ADDENDUM NO. 3

SUBJECT: Addendum No. 3 – Magnolia Avenue Streetscape Project

PROJECT NO.: 15A-R-0584 & 16A-R-0609

CASTING DETAILS

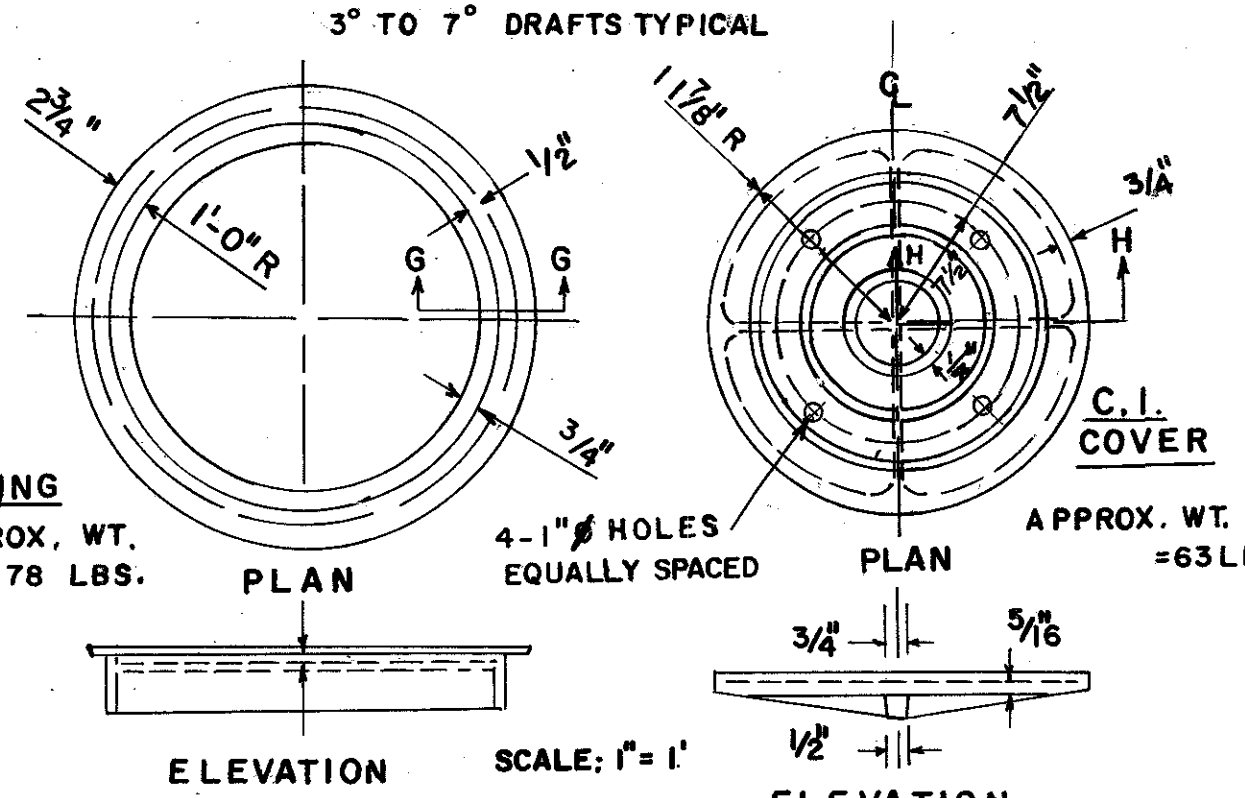
Question #18: Can precast be used for the GDOT Throated Inlets?

Question #28: Please provide specifications and details for Bid Item 22.12.6 GDOT Throated Inlet 1033F.

Response: Yes, GDOT has standard details for both precast and cast in place versions of the 1033F type basin. Details of the precast and cast in place version of the GDOT 1033F basin are included in this addendum.

Response: Details of precast and cast in place version of the GDOT 1033F basin are included in this addendum.

PROJECT No.	YEAR	SHEET No.	
15A-R-0584	2017	2B	
REVISIONS			
No.	DATE	BY	BRIEF DESCRIPTION
1	02-22-2018	MLK	ADDENDUM 3 - ITEM NO. REVISION

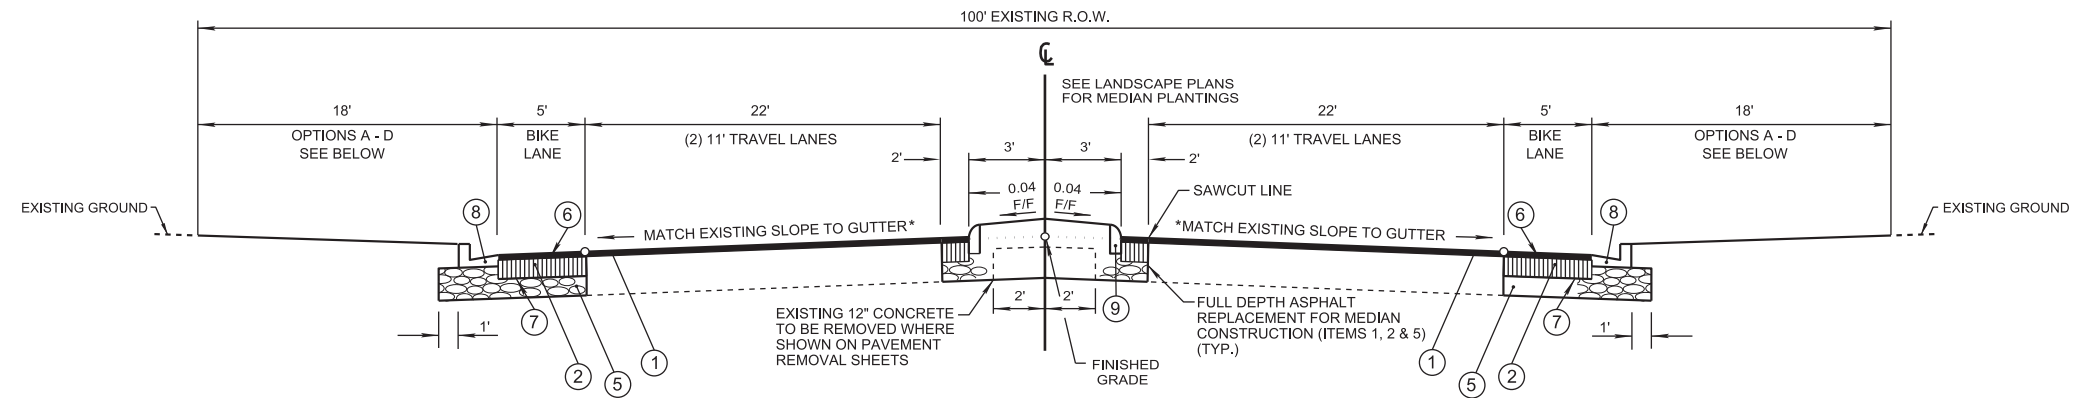
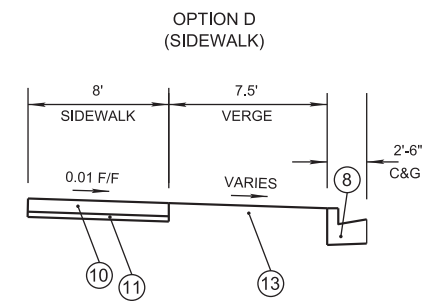
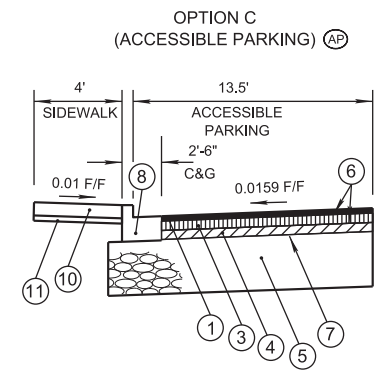
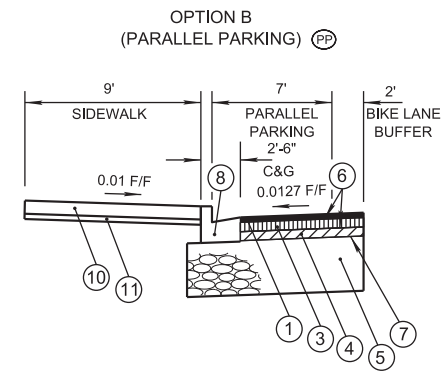
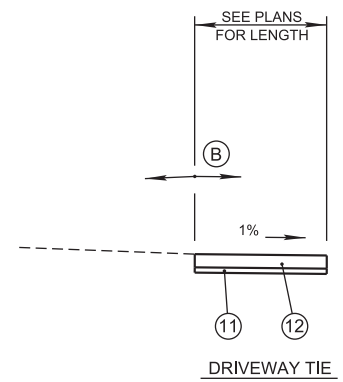
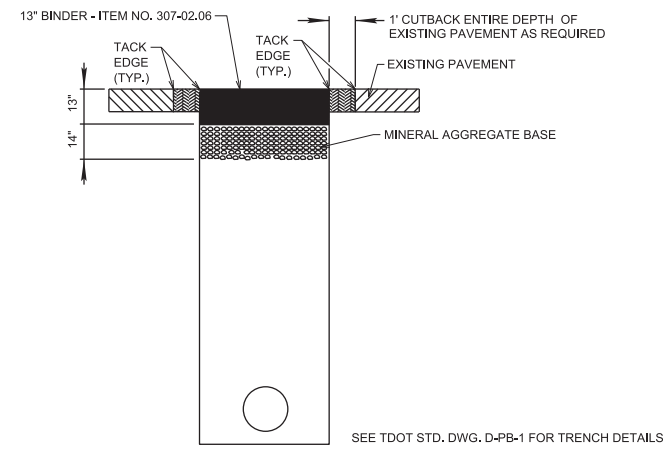
- h. Quantity for Item No. 63.10 was reduced
 - i. Pay Item No. 26.90 was added
 - j. Descriptions of Item Numbers A2620c, B3015b, B3020c were revised
- 2.) Phase I, Sheet 2B – Revised keynote 11

Question #56: The response to Addendum #2 question #14 states that base stone should be included in bid items 13.10, 13.12, 13.13, and 13.20. This contradicts the typical section sheets 2B (both Phases) and 2C (Phase 1), note 11 on those sheets refer to the 2" of stone as item 303-01. Please clarify? Also, what about the base stone for items 71.02, 71.04, and 71.06? Lastly, if the plans are revised to show that stone is to be included for these seven items, how does this affect the estimated quantities?

Response: The typical section sheets have been revised to reflect this change and are attached to this addendum. The base stone for the bench, trash receptacle, and bike rack pads will be paid for under the 71.04 item which now covers bench, trash receptacle, and bike racks pads. The quantity for Item Number 303-01 has been reduced to account these changes.

PROJECT No. 15A-R-0584	YEAR 2017	SHEET No. 2C	
REVISIONS			
No.	DATE	BY	BRIEF DESCRIPTION
1	02-22-2018	MLK	ADDENDUM 3 - ITEM NO. REVISION

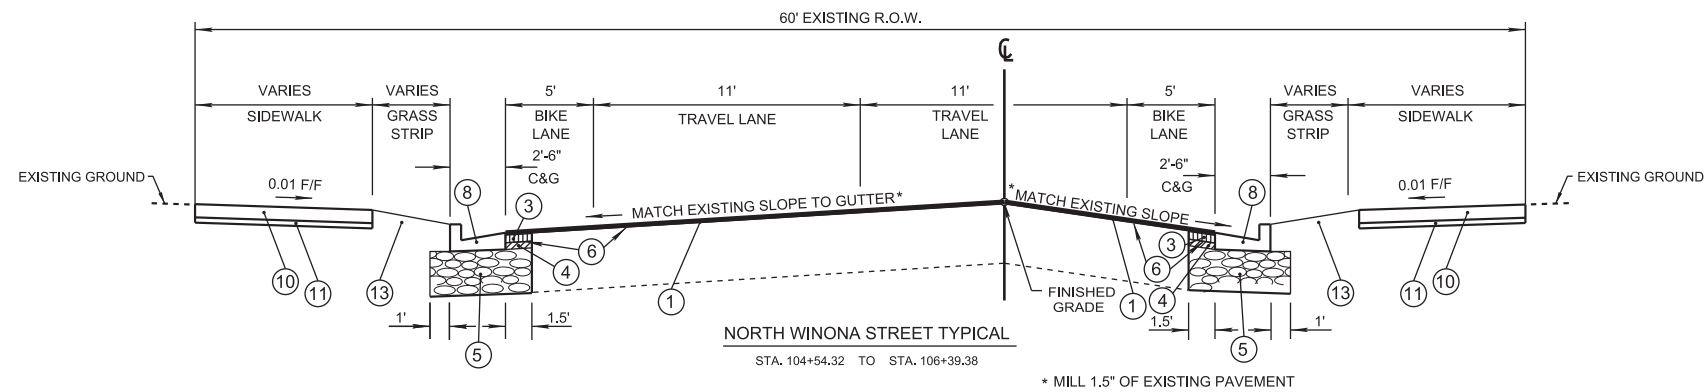
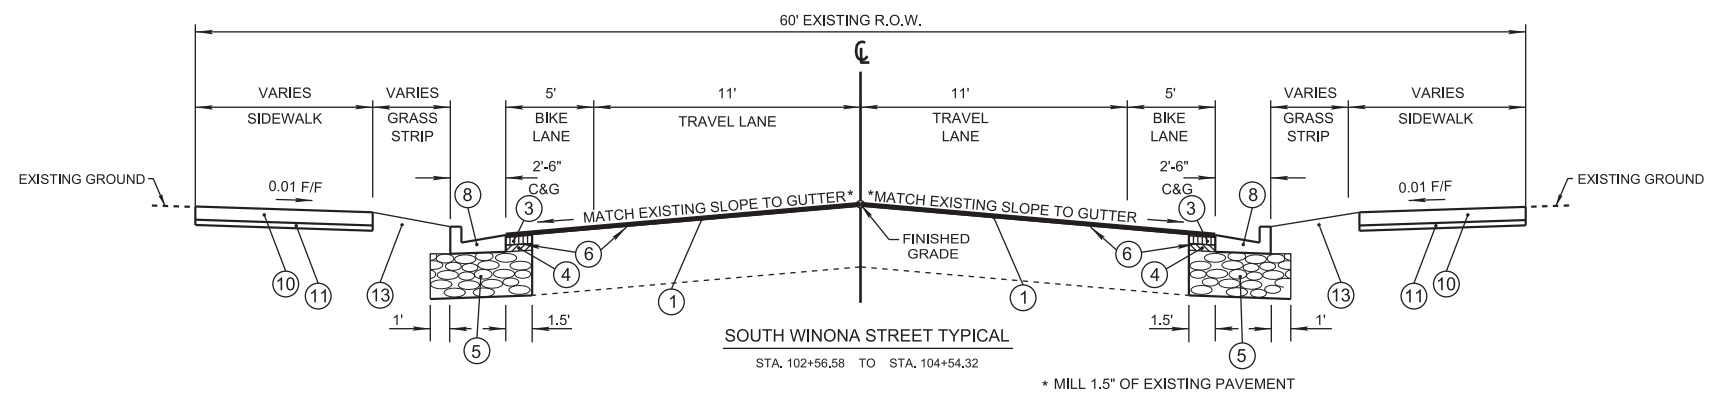
- 3.) Phase I, Sheet 2C – Revised keynote 11
- 4.) Phase I, Sheet 2E – Structure 1 revised to drain to 1C, not 1B
- 5.) Phase I, Sheet 2F – Street print XD detail added

PROJECT No.	YEAR	SHEET No.	
15A-R-0584	2017	6A	
REVISIONS			
No.	DATE	BY	BRIEF DESCRIPTION
1	02-22-2018	MLK	ADDENDUM 3 - REVISED ASP. REMOVAL

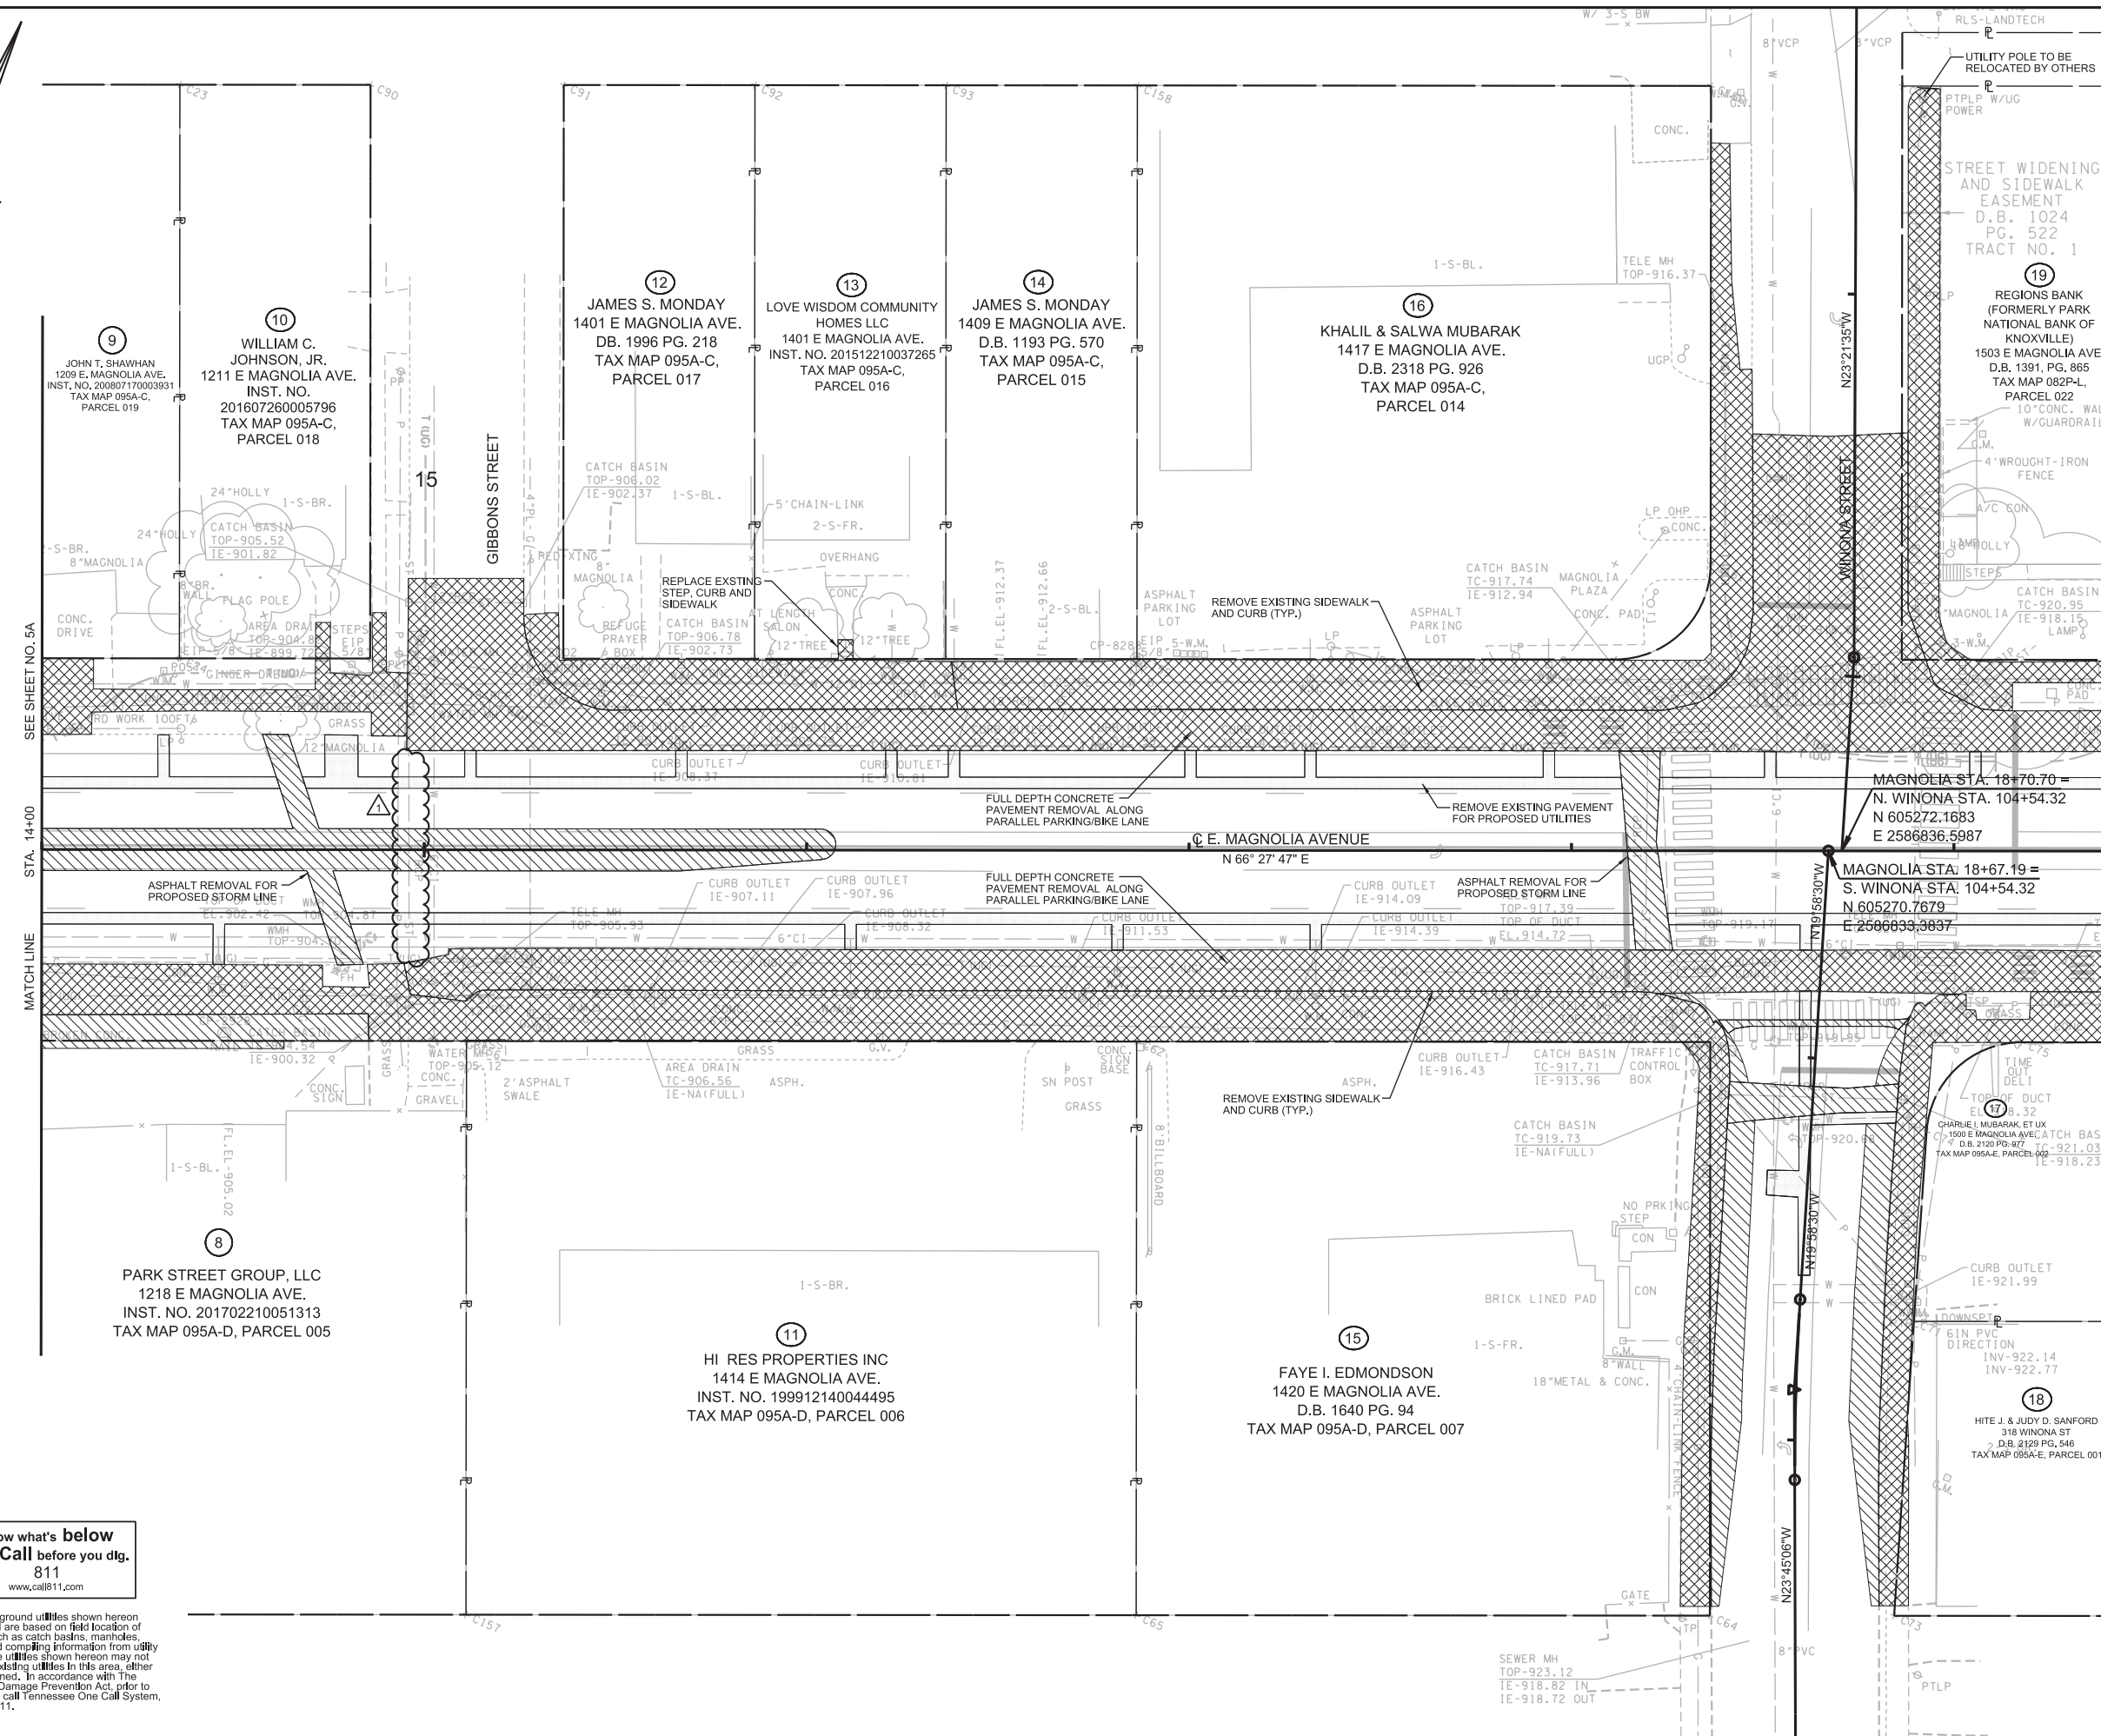
- 6.) Phase I, Sheet 5 – Displayed sanitary linework
- 7.) Phase I, Sheet 5A – Removed hatching where drain pipes are to be abandoned
- 8.) Phase I, Sheet 6A - Removed hatching where drain pipes are to be abandoned

PROJECT No.	YEAR	SHEET No.	
16A-R-0609	2017	2B	
REVISIONS			
No.	DATE	BY	BRIEF DESCRIPTION
1	02-22-2018	MLK	ADDENDUM 3 - ITEM NO. REVISION

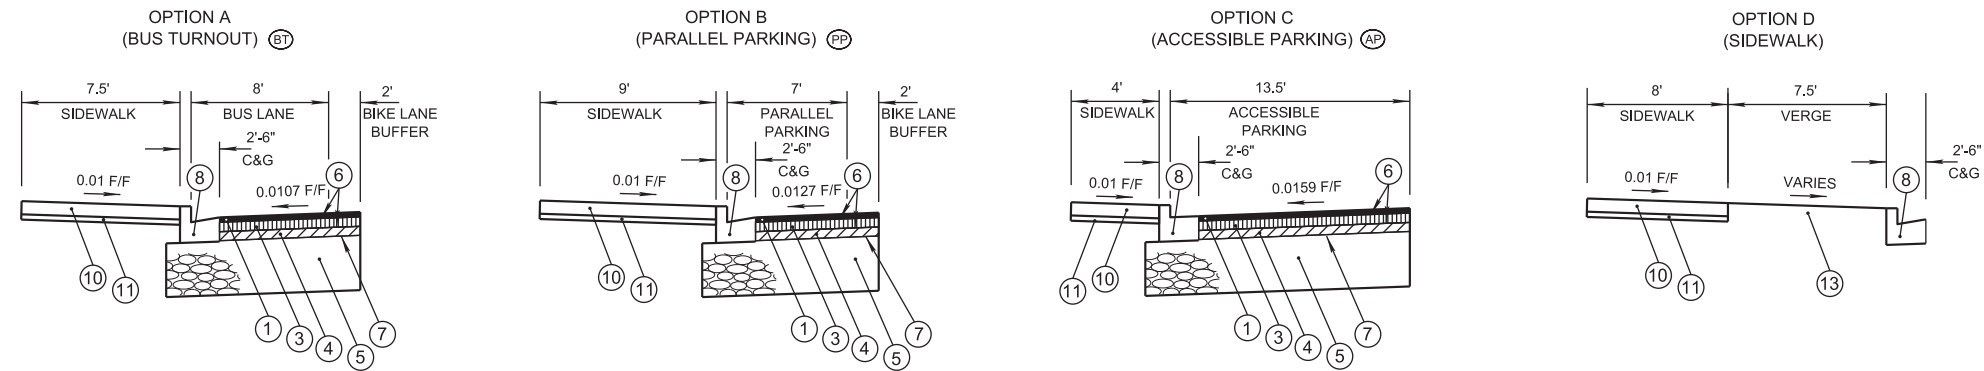
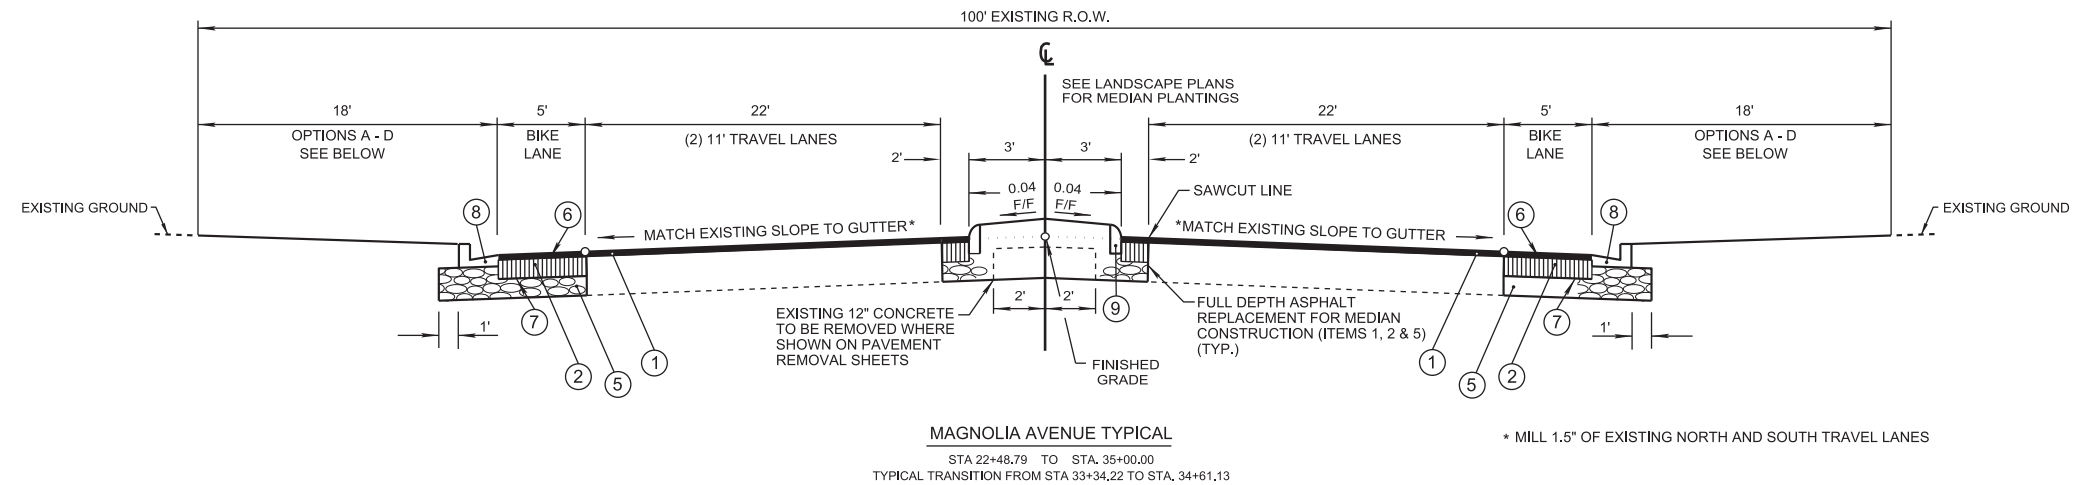
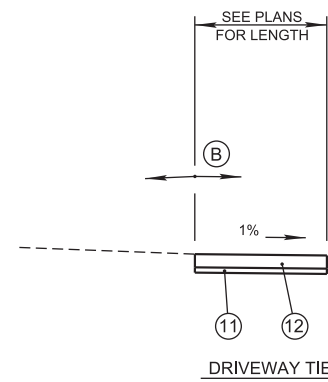
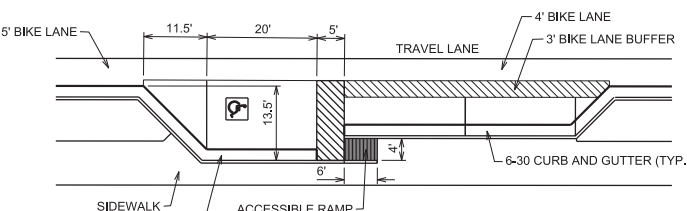
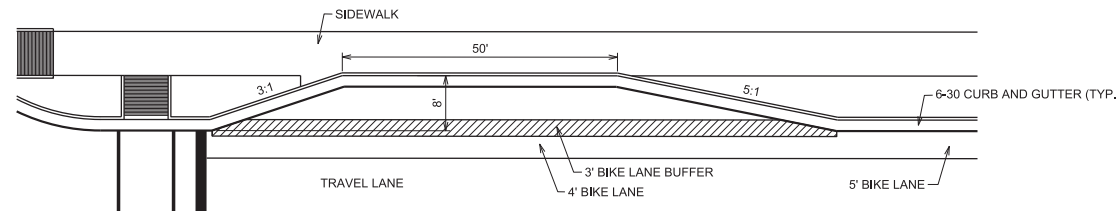
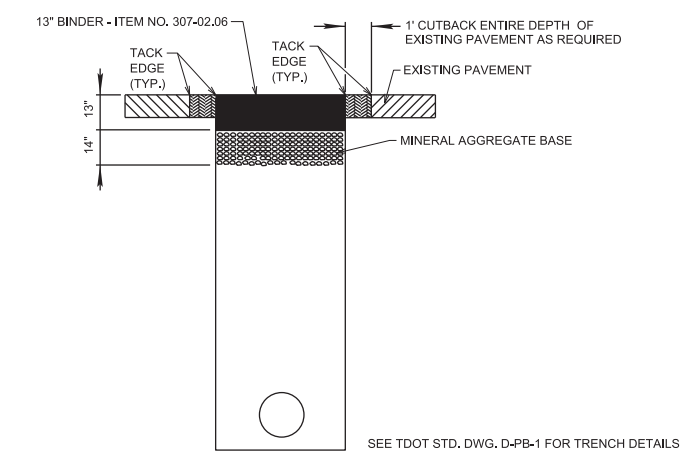
- 9.) Phase II, Sheet 2B – Revised keynote 11
- 10.) Phase II, Sheet 2D – Revised grate elevation for Structure 38A
- 11.) Phase II, Sheet 2E - Street print XD detail added
